Architectural Review and Historic Preservation Board Agenda Report

File: AR 20-05

RE: Architectural Review 20-05 (Bloom Energy)
1531 Esplanade, APN 003-024-005 and 003-023-024, et al

OVERALL SITE PLAN
 SCALE: 1" = 30'

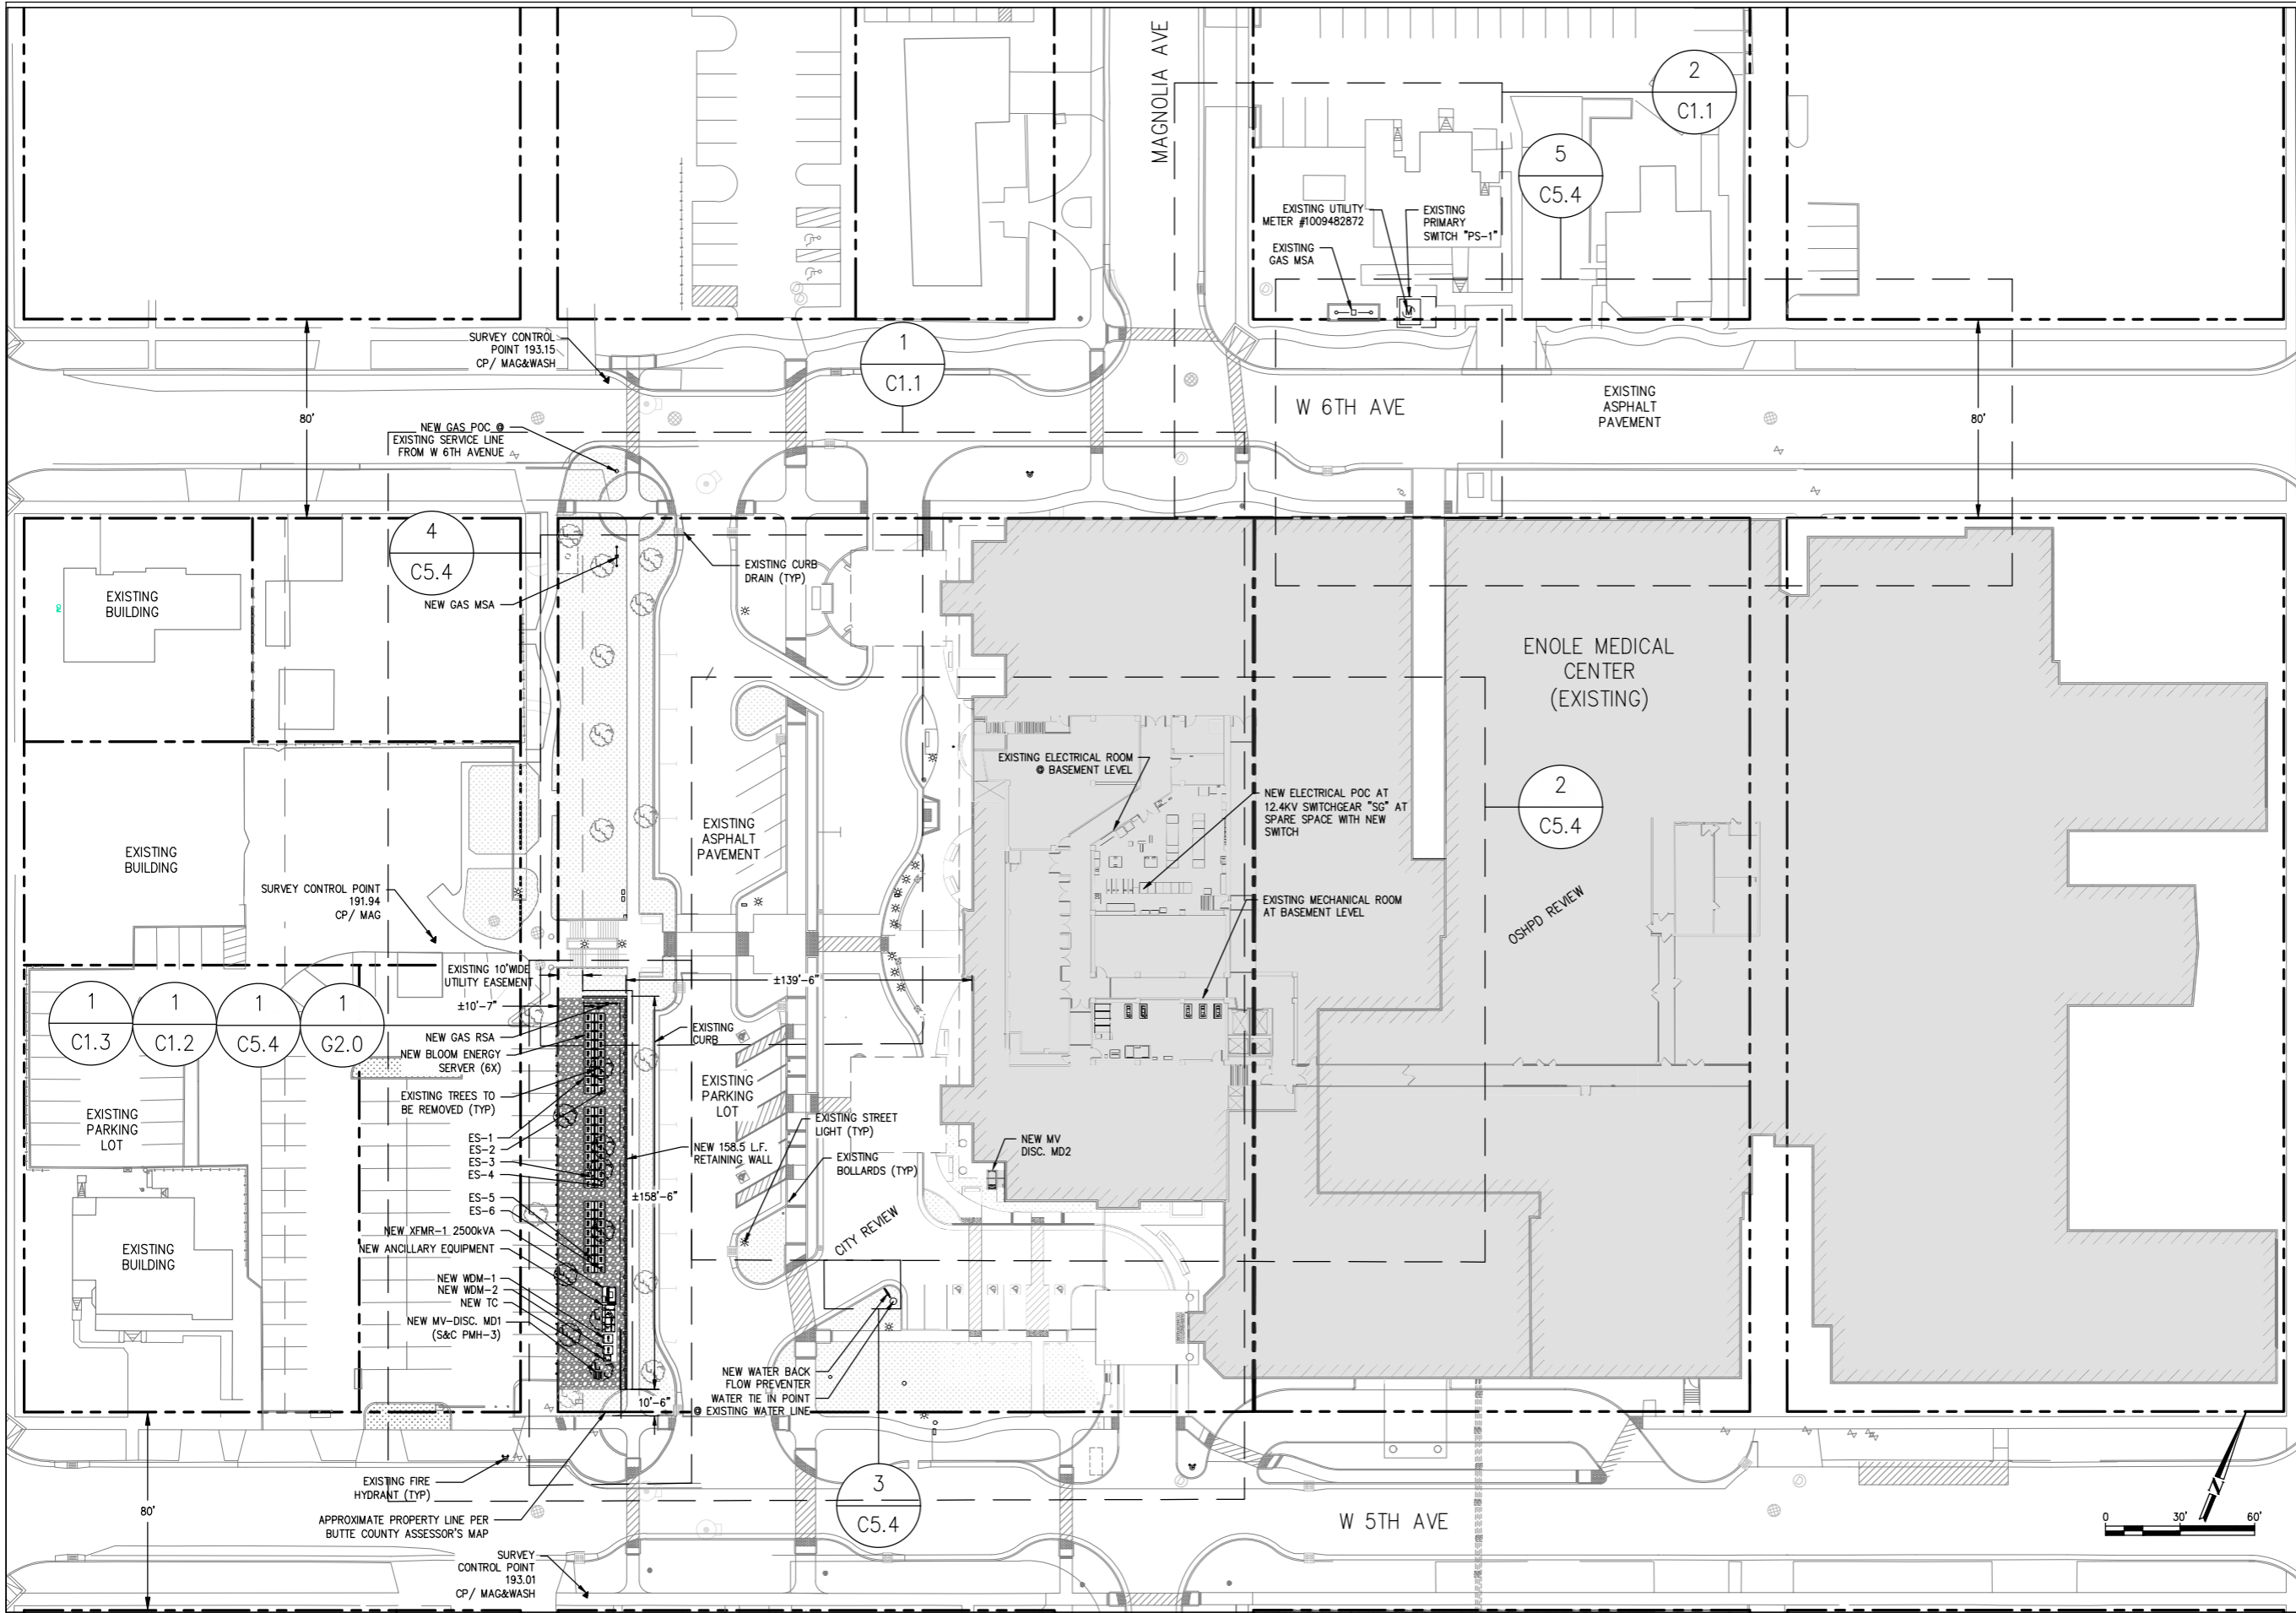
The proposed fuel cells would be set back approximately eleven feet from West 5th Avenue and would not alter the parking area or the formal garden portion of Enloe Park (see **Attachment B**, Site Plan). The fuel cells require no additional parking.

SHEET TITLE
COLOR ELEVATIONS

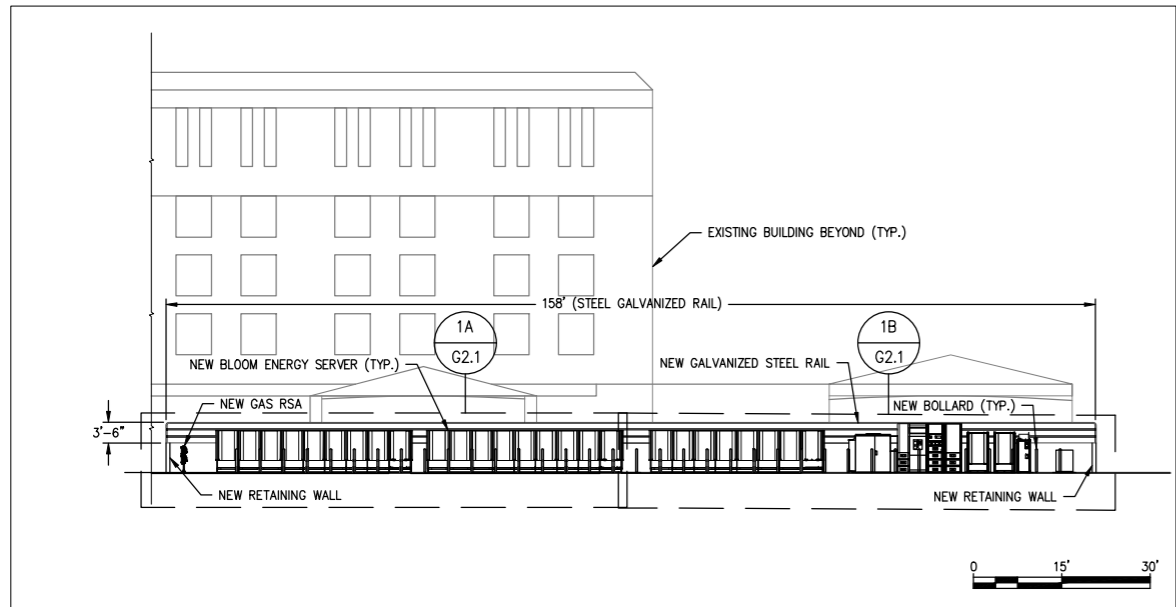
The proposed fuel cells would have a sleek, hypermodern appearance (see **Attachment C**, Rendering and **Attachment D**, Color and Materials Sample Panel). They would be set within an area partially screened by a cement retaining wall on three of their four sides. Condition #4 would require installation of a landscaped screen or living fence on the west elevation, which is proposed to be left open. That condition responds to both aesthetic and noise

3. Proposed project signage shall be permitted through a separate sign permit in compliance with CMC 19.74 (Signs).
4. Building plans shall include and prior to permit final the applicant shall install on the west side of the energy servers a screen to improve aesthetics. That shall consist of a fence between five and six feet in height planted with appropriate climbing vines or hung with other acoustically-reducing material of high aesthetic quality, or a living fence planted with appropriate thick native shrubs that will grow to at least five feet in height and create a hedgerow to provide relief from potential noise impacts. Staff shall field-verify such an installation prior to the operation of the Fuel Cells.
